To:	Mark Valeriotte (JDS) Greg Blaylock (JDS)	Date:	January 24, 2011
cc:	Maritz Rykaart (SRK)	From:	Lowell Wade (SRK)
Subject:	Doris North – North Dam Fillet Construction	Project #:	1CH008.033

Request for Information

To:	Mark Valeriotte, Greg Blaylock	Date:	February 15, 2011
cc:		From:	Lowell Wade, Maritz Rykaart
Subject:	Hope Bay Project – North Dam Additional Key Trench Excavation in Peat Zone	Project #:	1CH008.033

To:	Mark Valeriote	Date:	April 15, 2011
Company:	Hope Bay Mining Limited	From:	Maritz Rykaart, Lowell Wade
Copy to:	Greg Blaylock, Kevin Mather	Project #:	1CH008.033.0213
Subject:	North Dam Close-out Plan for April/May 2011 - FINAL

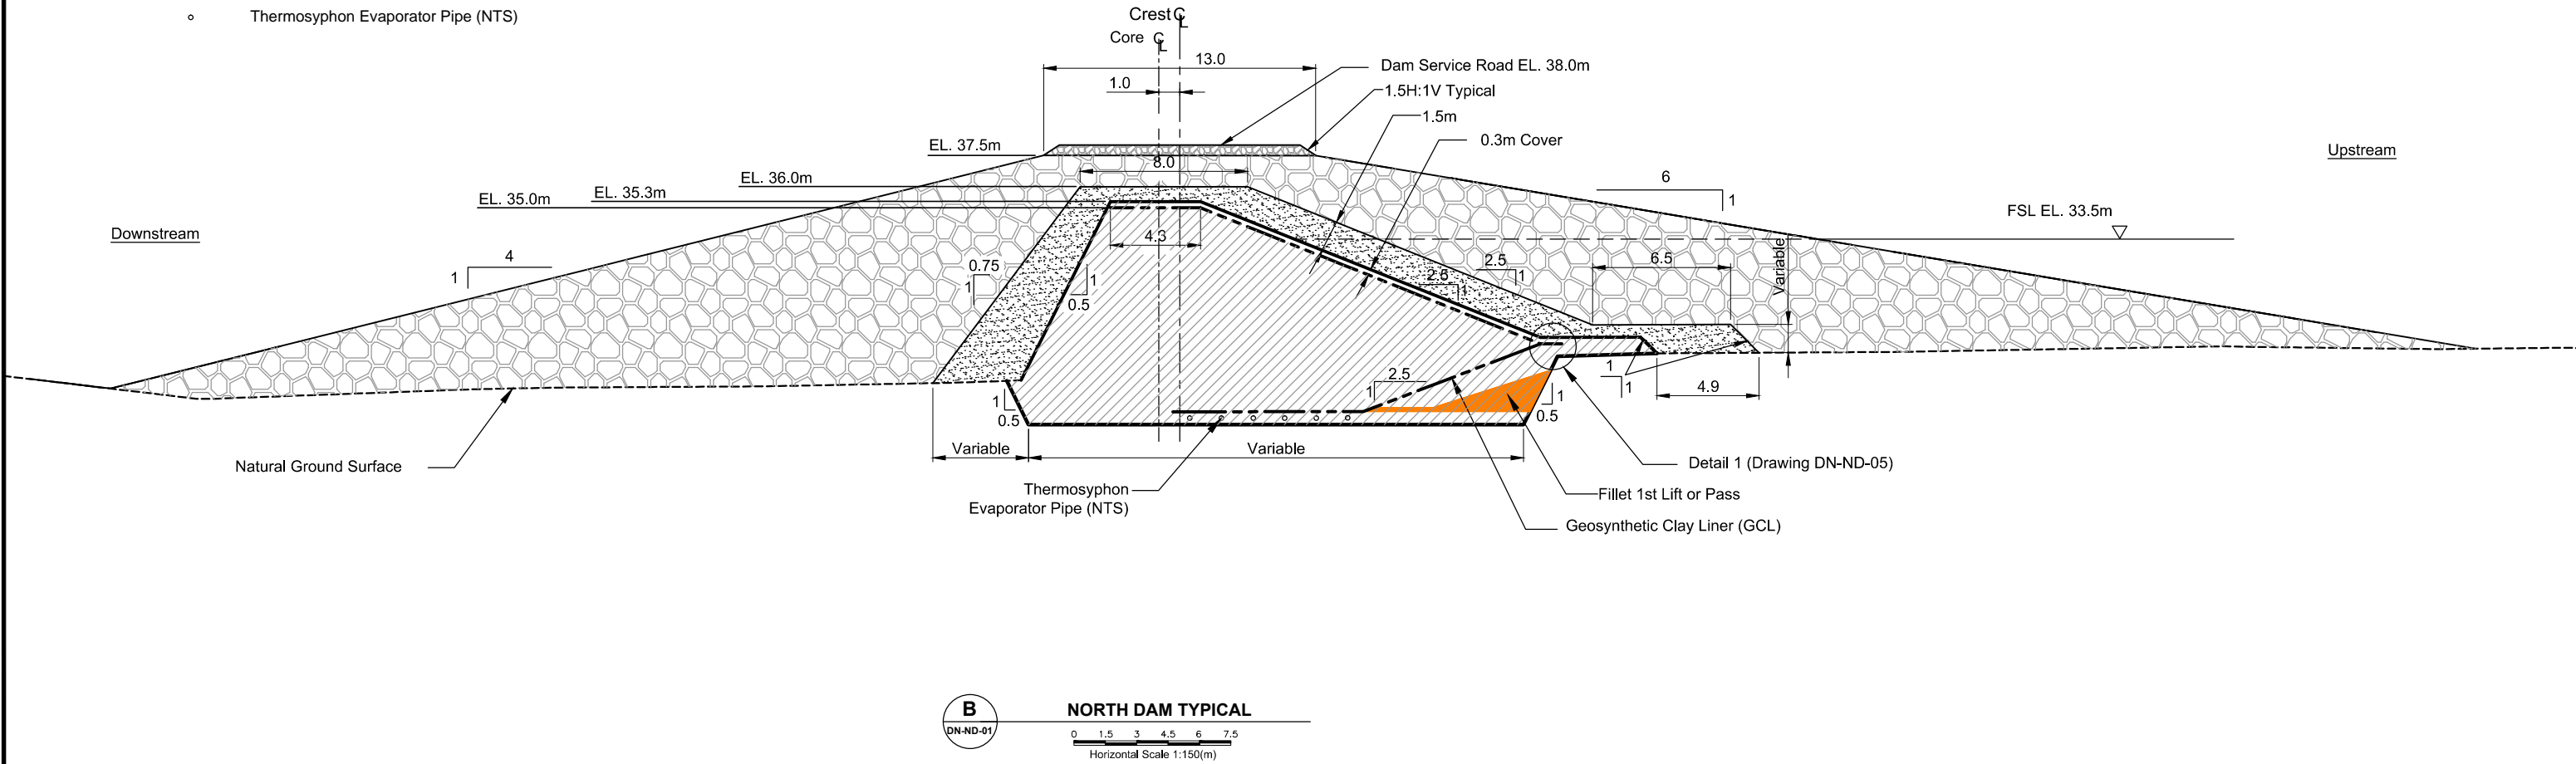
The “fillet” is the area of material below the up-stream liner and the base of the key trench. The technical specifications call for the construction of the “fillet” to be placed and compacted in thin horizontal lifts. This will be difficult due to limited space and narrow width of each lift which will become progressively narrower as the “fillet” reaches the top of the key trench. It has been proposed the fillet be constructed in a series of wedge shaped layers using moisture conditioned core material which is slightly drier than specified for constructing the core of the North Dam. This will allow the core material to be placed on an incline and not slump prior to freezing in-place. The core material will be place and compacted using an excavator bucket. The sequencing of the lifts are shown in the attached three figures.

SRK does not have an issue with the proposed construction methodology. No changes to the IFC drawing will be required

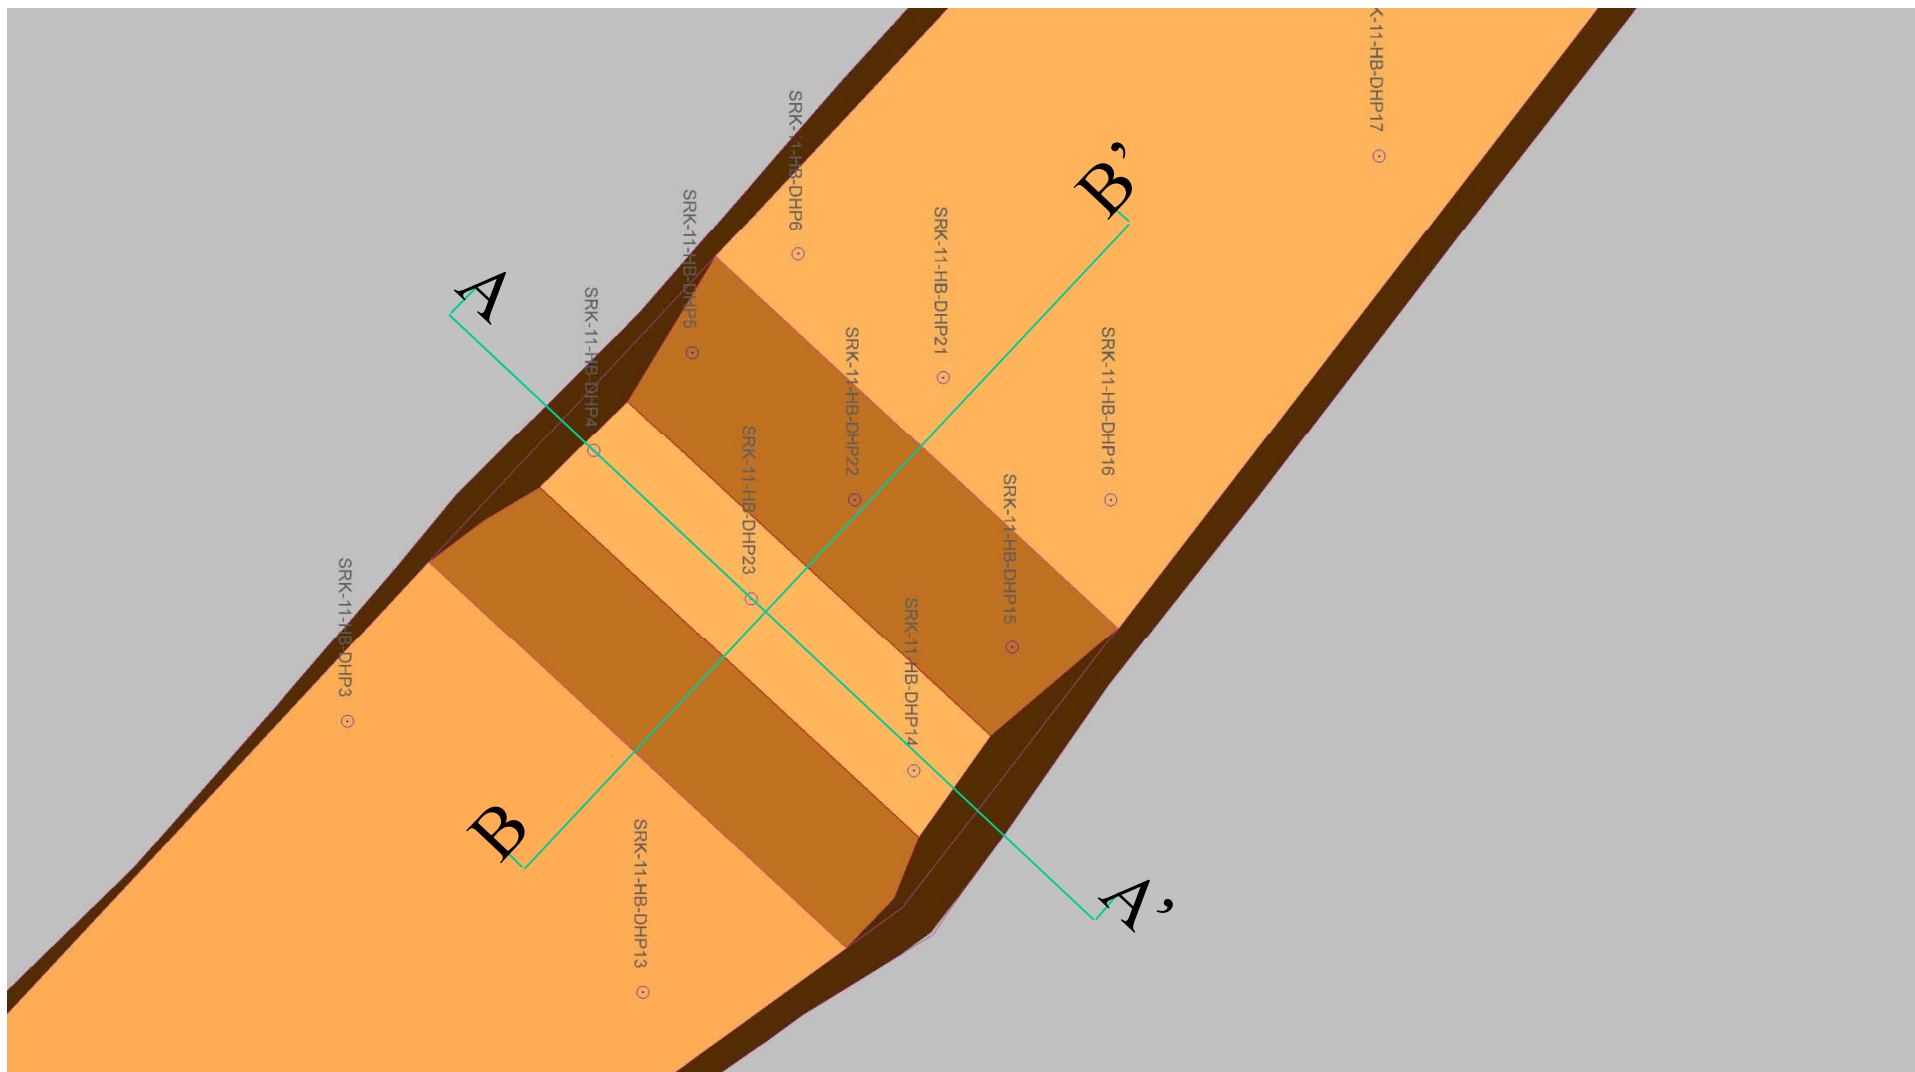
This peat and ice rich material must be completely removed, and replaced with saturated core material to ensure the integrity and performance of the dam. The additional excavation is about 625 m³ and consists of a trapezoidal cut with a horizontal 5 m base width at chainage 0+095, and 2H:1V slopes in the west and east directions intercepting the design key trench base at changes 0+82 and 0+99 respectively. The north and south sides of the additional excavation will be consistent with the existing key trench side slopes of 0.5H:1V. The additional excavation is variable in depth, with a maximum depth of about 5 m below original ground, or 2.6 m below the original key trench base design depth.

The attached Figures 1 through 6 illustrate the extent of the excavation, and provide stake-out coordinates for the additional excavation. A digital ACAD file will be submitted for use by the contractor.

DATE: Feb. 18, 2011
APPROVED: JK/EMR
FIGURE: ND-IE1

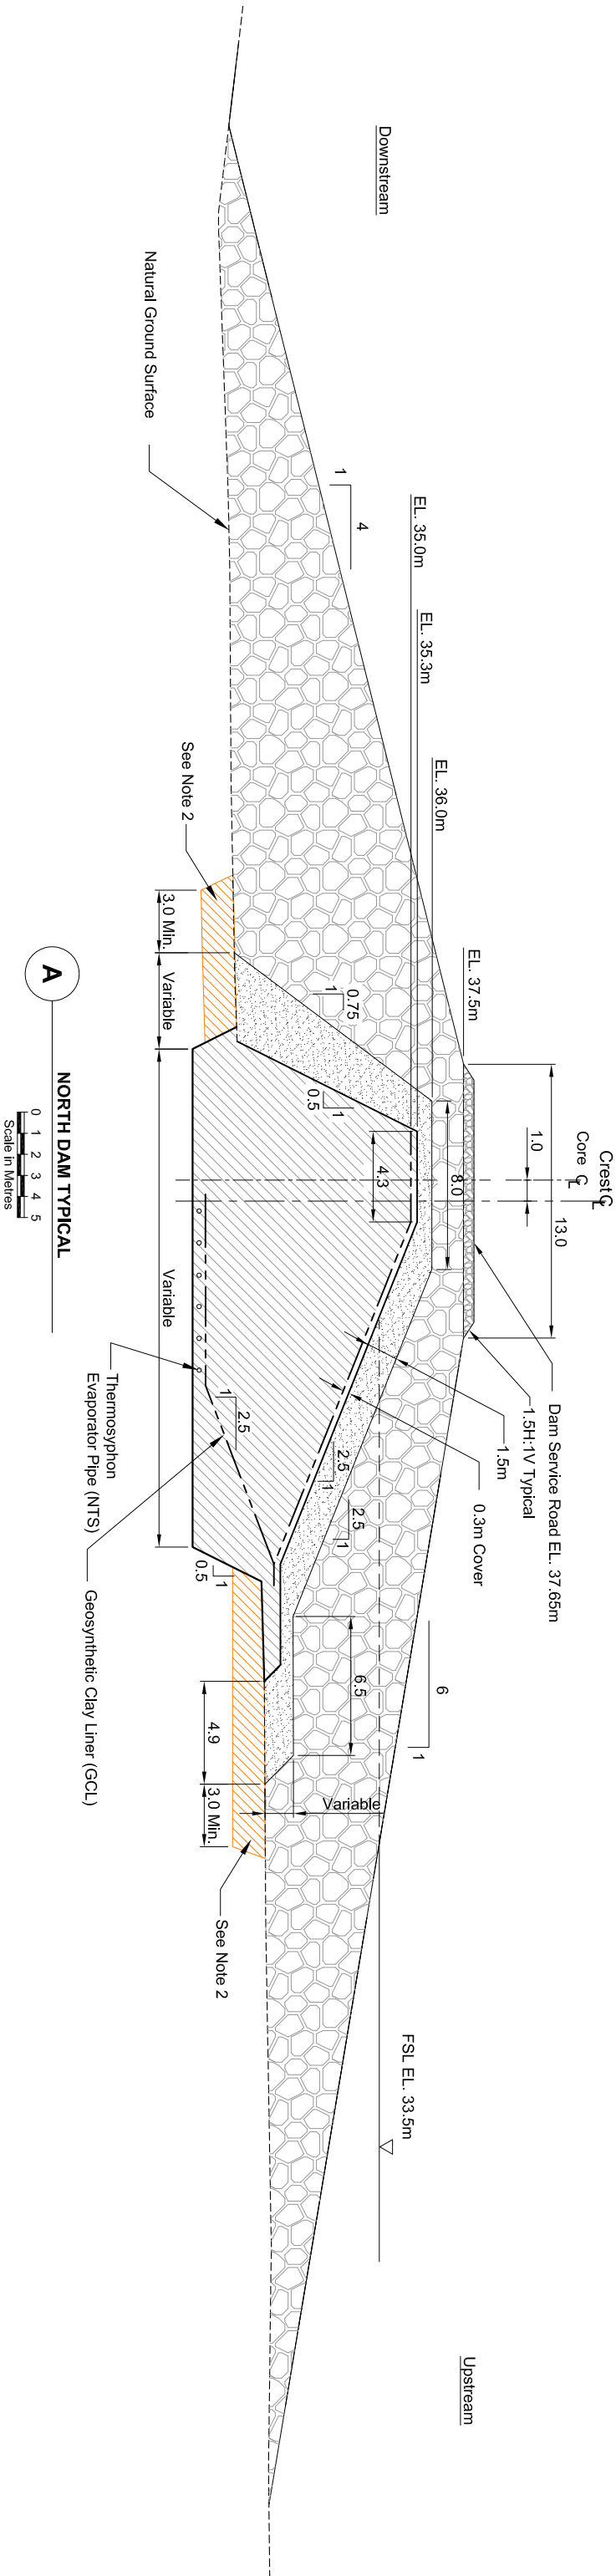
Visual inspection of the upstream and downstream slopes of the key trench at chainage 0+95 to 1+00 confirms the presence of a zone of massive surface ice, as much as 0.5 m thick and about 4 to 6 m in width. It has been noted in the field that thinner lenses of ice interlaced with layers of ice saturated alluvium extend to a depth of about 1.5 m below ground; this is above the invert level of the key trench. Reconnaissance inspection suggests that the surface ice follows along the Tail Lake Creek course, and therefore its presence is directly related to the normal flow of the Creek. Due to the direct correlation to the Creek it is estimated that this zone of surface ice should be approximately constrained around the vicinity of chainage 0+80 to 1+00. If this ice remains in place, and should it thaw, it could lead to local differential settlement of the transition and ROQ zones in this area.

To prevent this settlement from happening, the zones of massive ice needs to be removed and replaced with suitable fill. Rather than using mass excavation techniques, SRK recommends that the ice be visually chased at surface and only relevant section be ripped out. Dental cleaning is not required, with the intent being to remove massive ice rather than smaller lenses of ice less than 10 cm. It should be noted that this ice should be chased to at least 3 m beyond the interface point between the Transition and ROQ zones, both upstream and downstream. Details on the required minimum upstream and downstream extents of this massive surface ice excavation can be found in figure ND-IE1 and ND-IE2.

Preferred Close-out Plan

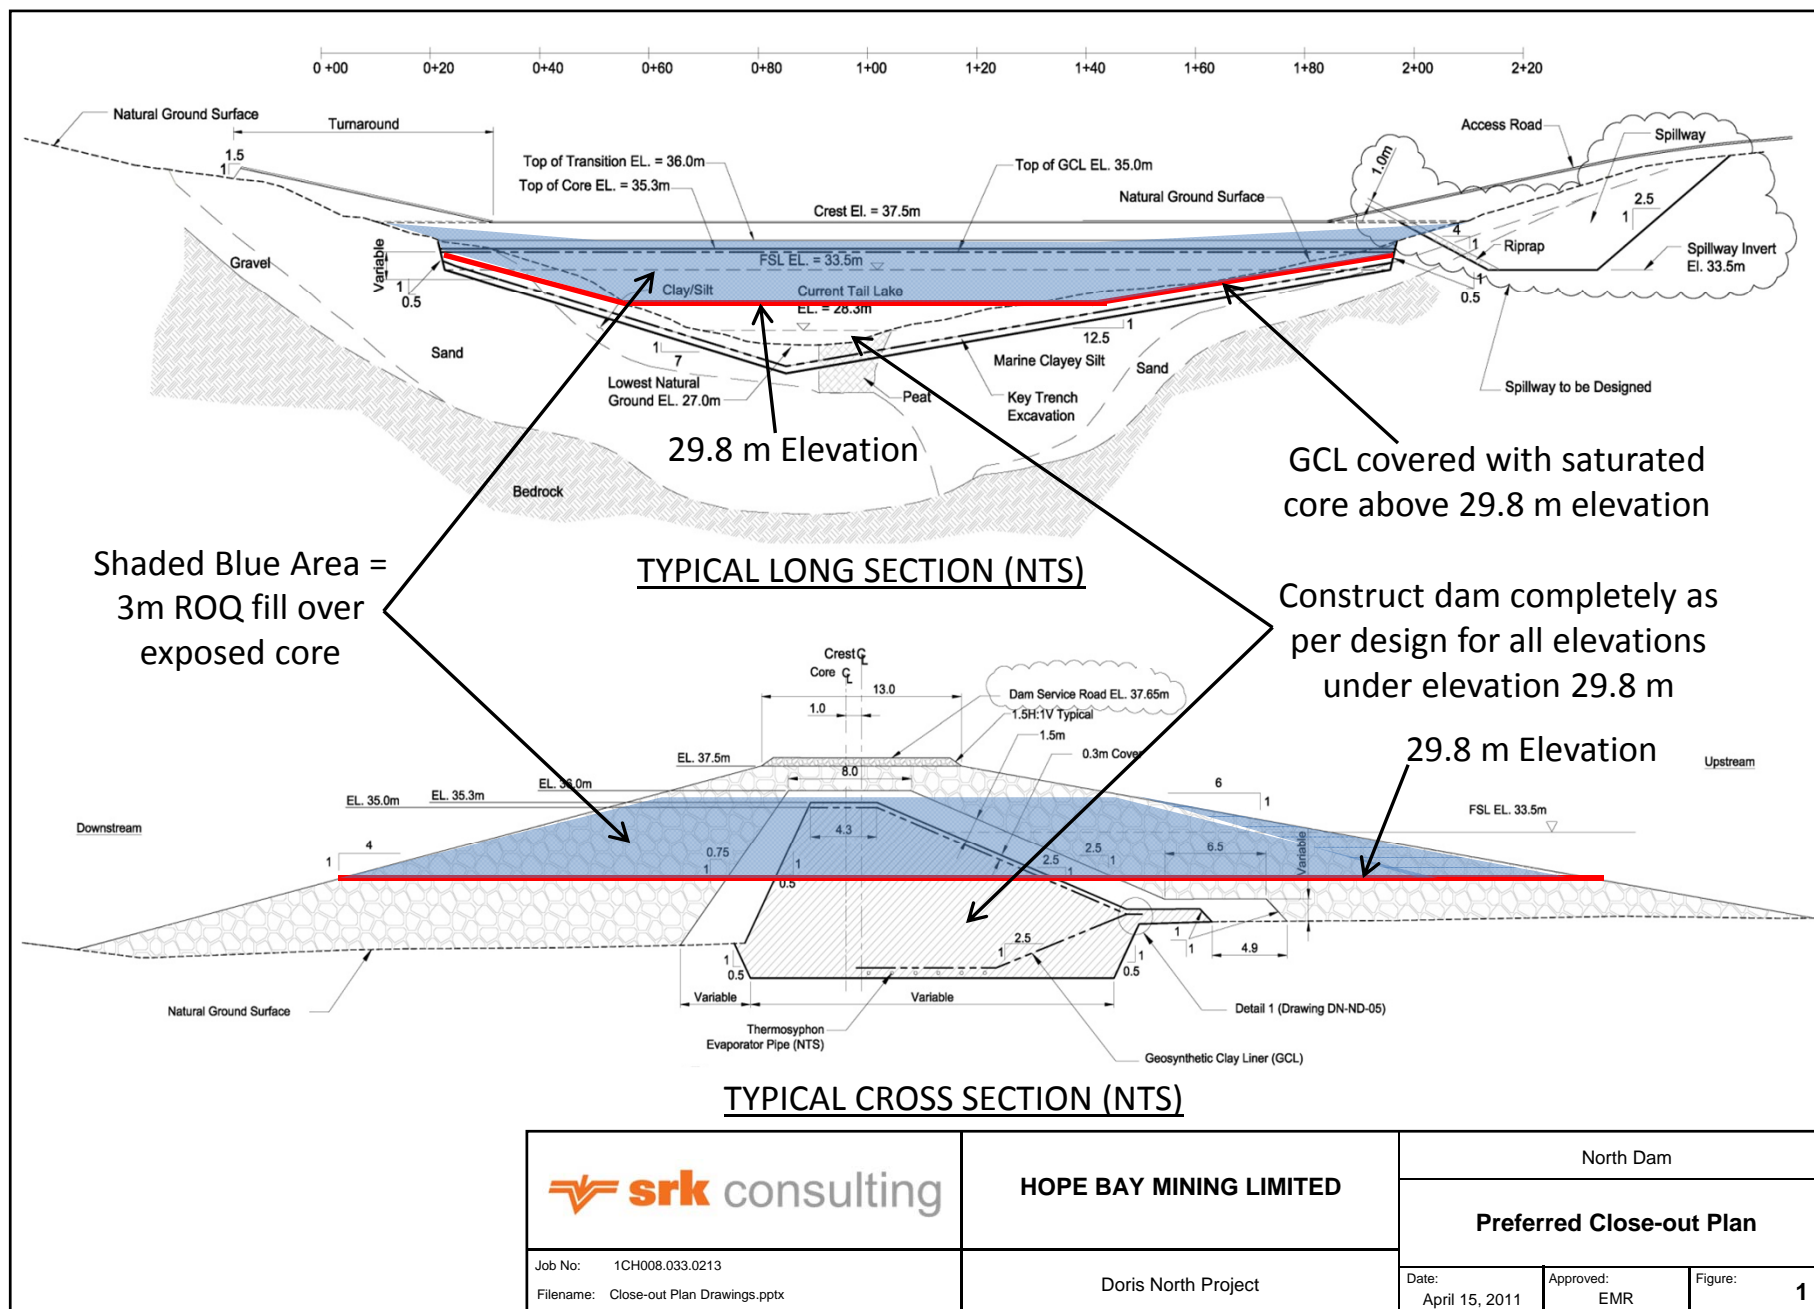
The preferred close-out plan (Figure 1) will continue the construction of the North Dam in accordance with the design, but with temporary modifications as follows:

- Install all evaporator pipes and radiators and commission the thermosyphons.
- Cover all evaporator pipes with saturated core material.
- Install all of the lower GCL (even those at elevation greater than 29.8 m), and cover with at least 500 mm (2 lifts) of saturated core material.
- Continue to construct the frozen core superstructure, as per design to elevation 29.8 m. This includes the installation of the upper CGL as appropriate, and covering it with saturated core material.

- Complete the construction of both upstream and downstream abutments of the dam to elevation 29.8 m (this includes both ROQ and Transition material).
- Cover all of the exposed core material with 3 m of ROQ to act as temporary thermal protection until dam construction commences (a "marker" material layer could be placed if deemed necessary from a constructability perspective).
